Service Information

Category S	Repair Guidance	Ref. No. R073/13	Page 1 of 4
Coverage <input type="checkbox"/> Distributor only <input checked="" type="checkbox"/> Please inform your dealers		Date Issued September 30, 2013	
Please convey this information to your <input type="checkbox"/> Director <input checked="" type="checkbox"/> General Manager <input checked="" type="checkbox"/> Warranty Dept. <input checked="" type="checkbox"/> Parts Dept. <input checked="" type="checkbox"/> Training Dept. <input checked="" type="checkbox"/> Field Rep.		Date Revised	
Applicable Model CX-5 (KE) without power seat system		Applicable Countries or Specifications Worldwide

Subject: Noise from under the driver seat

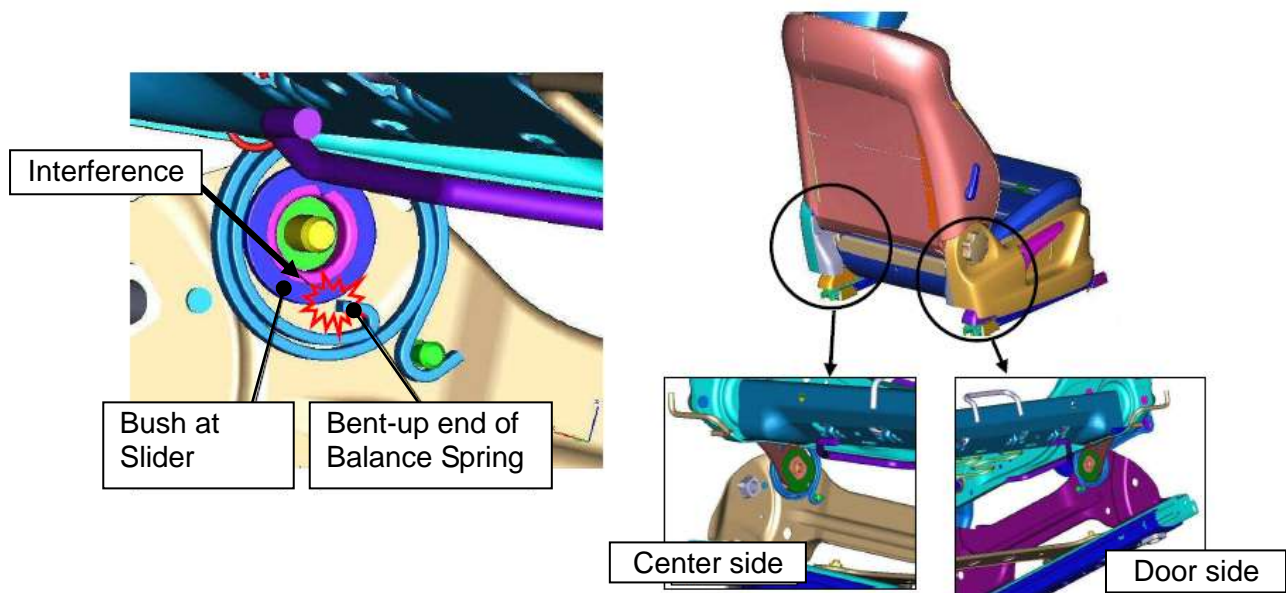
The bent-up end of balance spring interferes with the bush at slider causing a rasping noise.

Clearance between the balance spring bent-up end and the bush at slider has been increased.

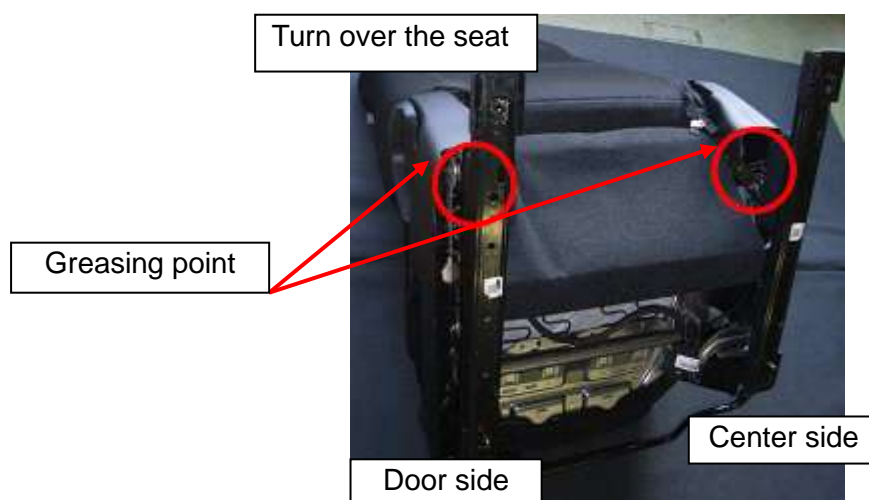
Verification: Verify if noise is occurring from around the seat lifter.

Repair: Remove the seat and apply grease at the interfering point.
Recommended grease: Molybdenum disulphide grease

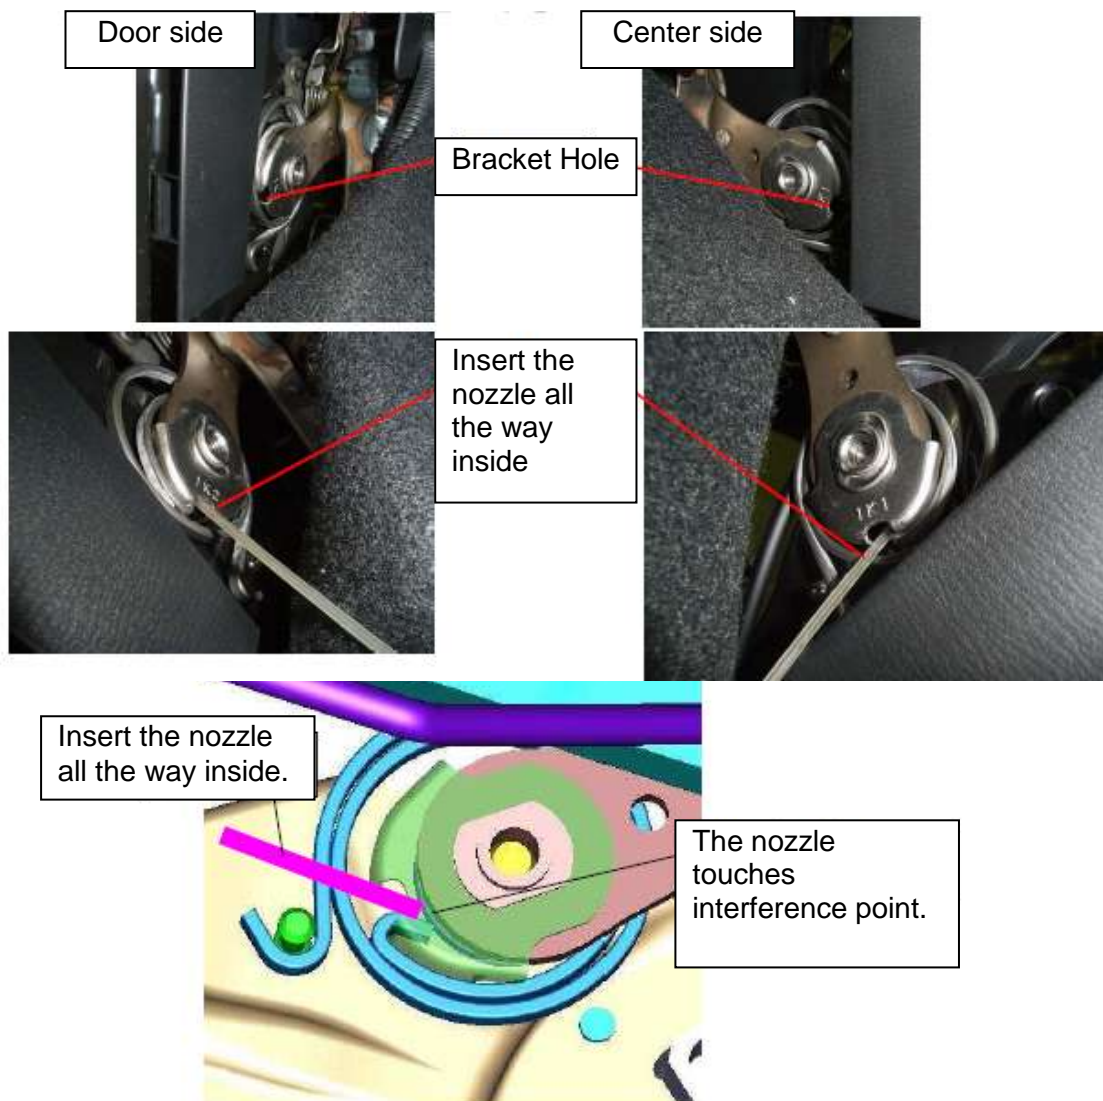
1. Set the seat lifter in the highest position.
2. Remove the front seat following the procedure in Workshop Manual "FRONT SEAT REMOVAL/INSTALLATION".
3. Turn the seat upside down as shown in picture.

4. Insert the grease spray nozzle from the bracket hole to all the way inside until the nozzle touches the interference point causing the noise.

5. Apply grease for one second.
Note: If it is sprayed too much, excess grease adheres between the balance spring plates and it will cause a new noise.
6. Install the removed parts in the revised order of removal.
